Item ID: D412-704-045

DART SERVICE INSTRUCTION

TO AMEND IIN-D412-704 REV. C OR EARLIER

PURPOSE

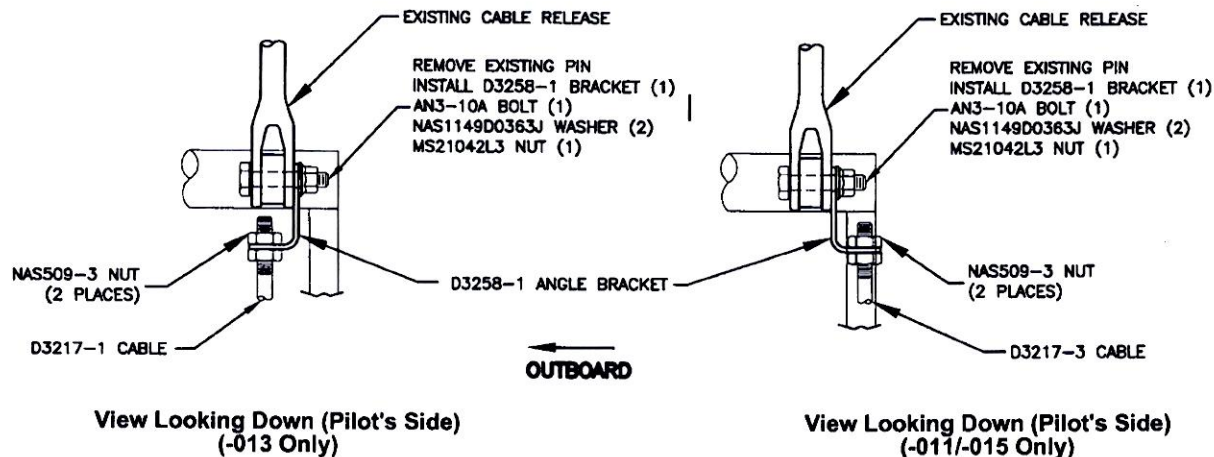
PART LIST CORRECTION

Revise Part Lists in IIN-D412-704 & ICA-D412-704 as follows:

Qty -043	Qty -045	Part Number	Description
X		D205-704-043	CABLE ASSEMBLY (205)
	X	D412-704-045	CABLE ASSEMBLY (210/212/214/412)
1	1	AN3-10A	BOLT

Qty -043	Qty -045	Part Number	Description
X		D205-704-043	CABLE ASSEMBLY (205)
	X	D412-704-045	CABLE ASSEMBLY (210/212/214/412)
1	1	AN3-13A	BOLT

Figure 5 - Detail L or Figure 25-4 - Detail L

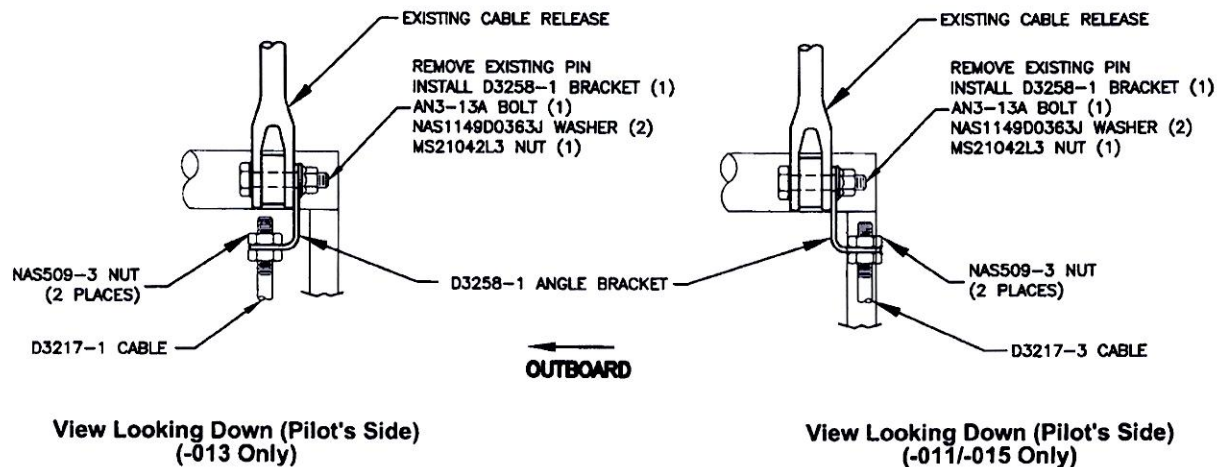
The purpose of this Dart Service Instruction is to correct part number error in Installations Instruction IIN-D412-704 Rev. C or earlier and Instructions for Continued Airworthiness ICA-D412-704 Rev. 4 or earlier. The AN3-13A bolt should be replaced with an AN3-10A bolt in Figure 5 - Detail L in IIN-D412-704 and Figure 25-4 Detail L in ICA-D412-704. See sheet 2.

FIGURES CORRECTION

Revise Detail L Figure 5 of IIN-D412-704 and Detail L Figure 25-4 of ICA-D412-704 as follows:
